REMARKS/ARGUMENTS

The Office Action mailed March 16, 2005, has been received and reviewed. Claims 1 through 51 are currently pending in the application. Claims 1 through 21 and 42 through 46 have been withdrawn from consideration as being drawn to non-elected inventions and have been canceled.

Fig. 8

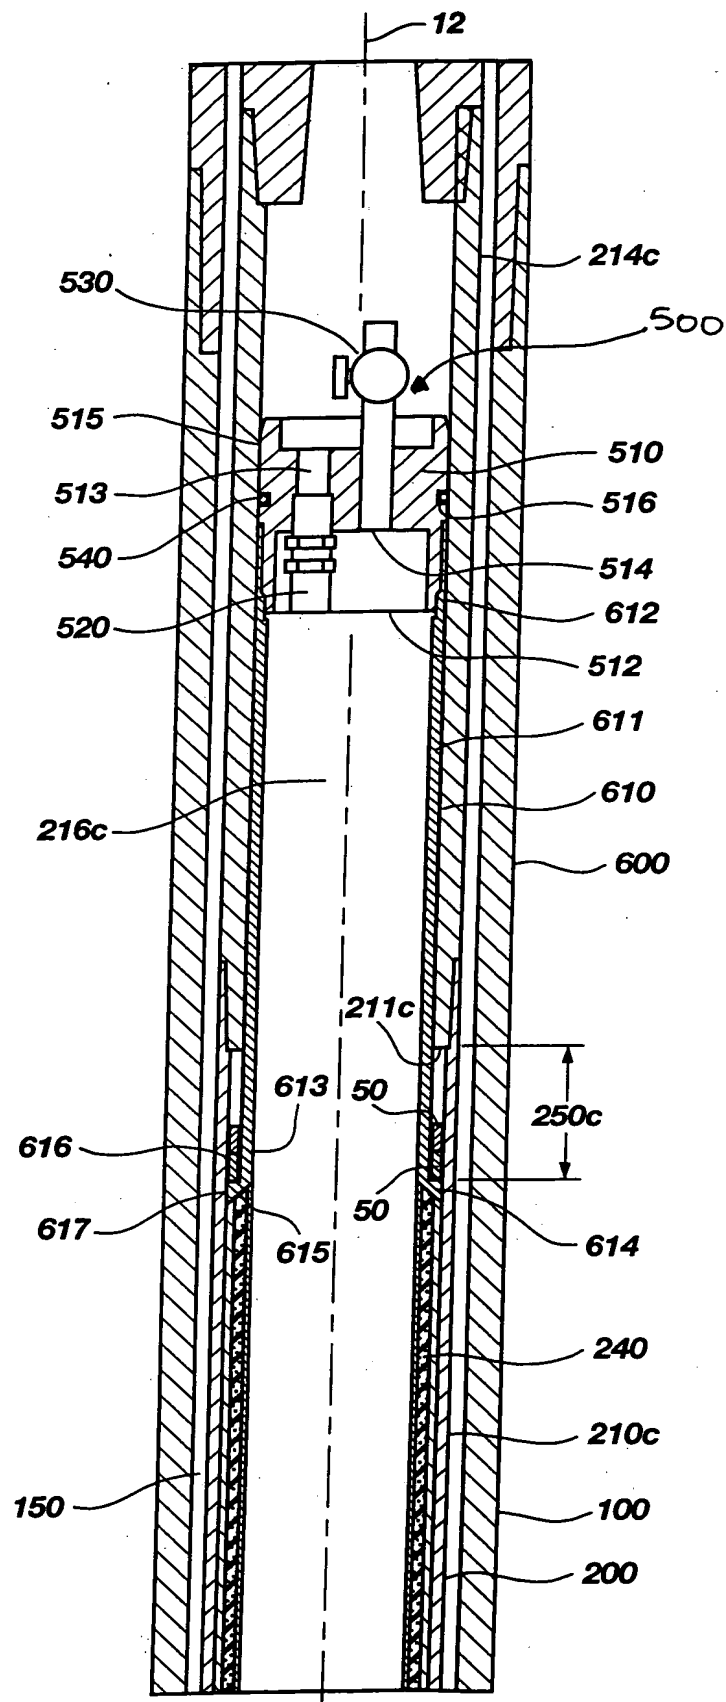
The attached sheet of drawings includes changes to FIG. 8. The attached sheet replaces the previous drawing sheets submitted for FIG. 8. In FIG. 8, previously omitted element 500 has been added. (See attached Replacement Sheet(s) and Annotated Sheet(s) Showing Changes.)

The drawings have been objected to under 37 CFR 1.84(p)(5) for not including reference numeral 500 mentioned in the description. Applicants respectfully traverse, in that reference numeral 500 is already shown in drawing FIGS. 1C and 12C, but has been added to amended FIG. 8, the latter submitted with this amendment, to further address the Examiner's concerns.
